Gachsaran Polymer Industries Company PIDMCO	Gachsaran Polymer Industries Company HDPE Plant				
	Evaporator (Chiller) Drawing		 		
PO No.: GPIC-PT-MA-PO-000-3029	Document Number: VD-GPIC-MA-3029-3029-0089	Rev. 02	Page 1 of 10

Evaporator (Chiller) Drawing

PO No.: GPIC-PT-MA-PO-000-3029
 DRAWING TITLE: EVAPORATOR (CHILLER) DRAWING (E-6101) (GENERAL ARRANGEMENT)
 DRAWING NO.: VD-GPIC-MA-3029-3029-0089
 REV. SHEET NO. SIZE: 02 3 OF 10 A3

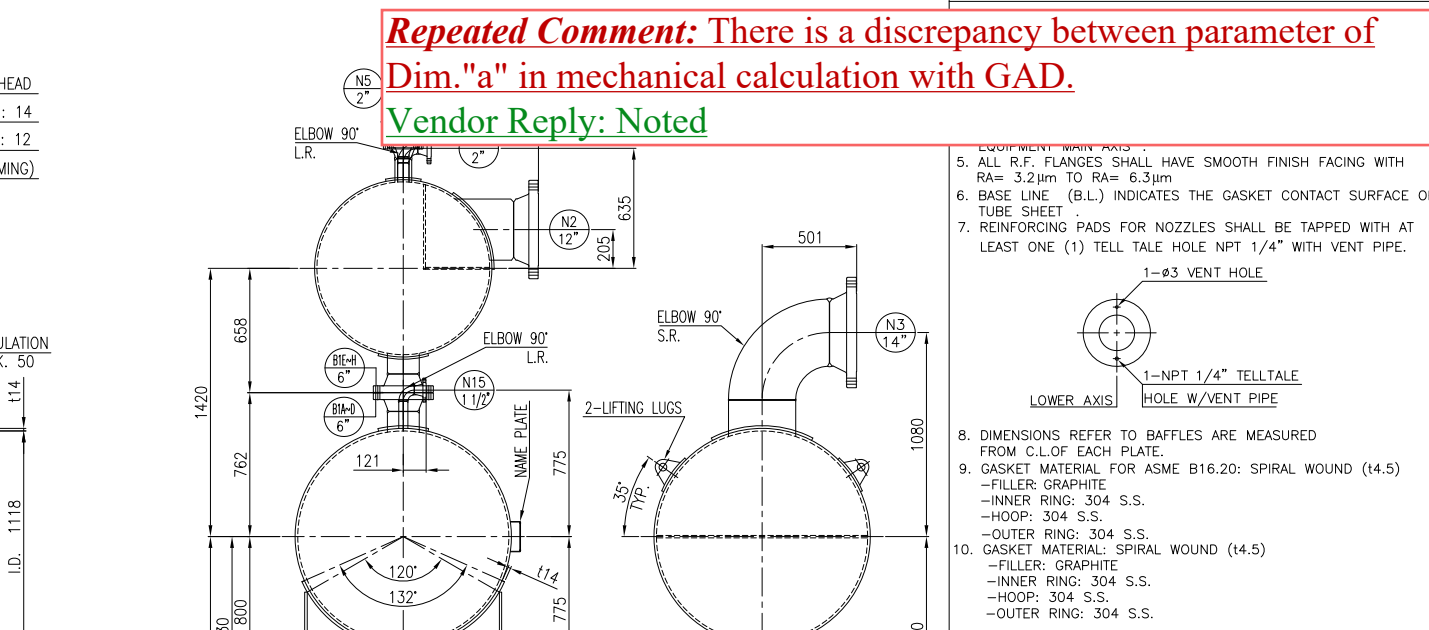
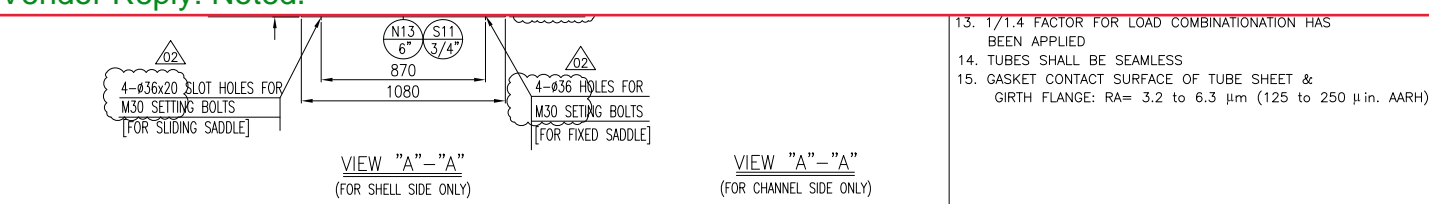
EIED previous comment:
 1- In order to avoid any further comments/change in accordance with future P&ID updates, the vendor is requested to specify the allowable nozzle loads for all nozzles in the "nozzle table".
Vendor Reply: The allowable nozzle load has been reported for all process nozzles. This point is not applicable for other nozzles.
EIED Reply/ repetitive comment:

- Rejected. inappropriate reply.
 - Vendor shall specify the allowable Nozzle loads for all the tie-in points with EIED. (as an e.g., the N14 Nozzle is Tie-in point as per the package's P&ID)

- Vendor is strongly recommended to specify the allowable nozzle loads for all the existing nozzles In order to avoid any further comments/issues in accordance with future P&ID updates or the vendor's mistakes.
Vendor Reply: Already allowable nozzle loads have been specified for client tie-in points and inlet/outlet nozzles. Anyhow we added allowable nozzle load for nozzle N14 (PSV) although it is not required.

Repeated Comment: There is a discrepancy between parameter of Dim."a" in mechanical calculation with GAD.
Vendor Reply: Noted

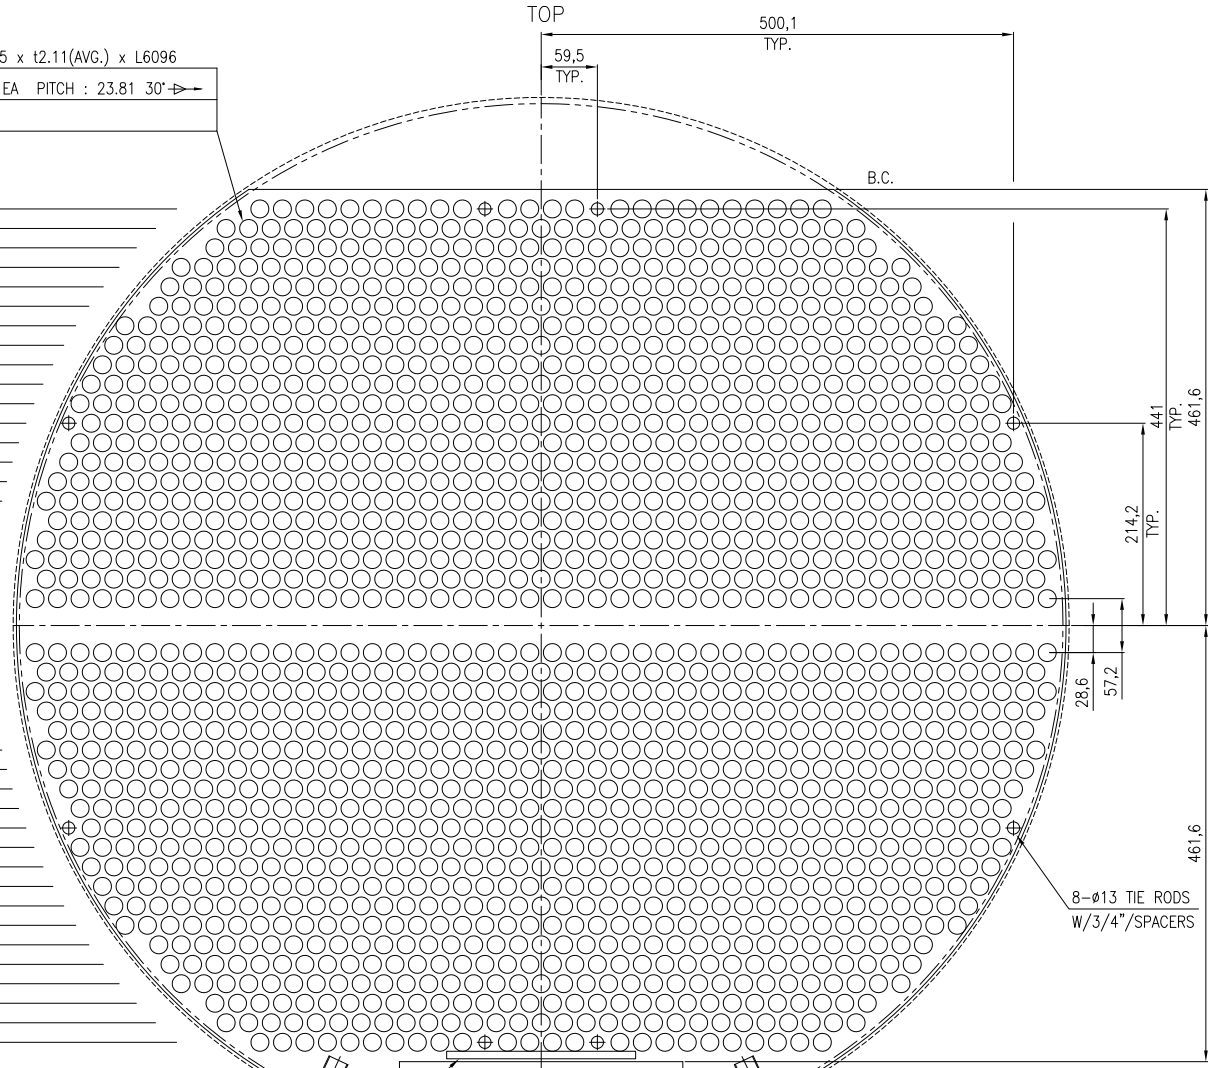
Please note that, body and bundle detail drawing will not be checked by EIED-ME (Issued for information), and the vendor shall be fully responsible for any discrepancy between Calculation, GAD and Body/Bundle detail drawing.
Vendor Reply: Noted.
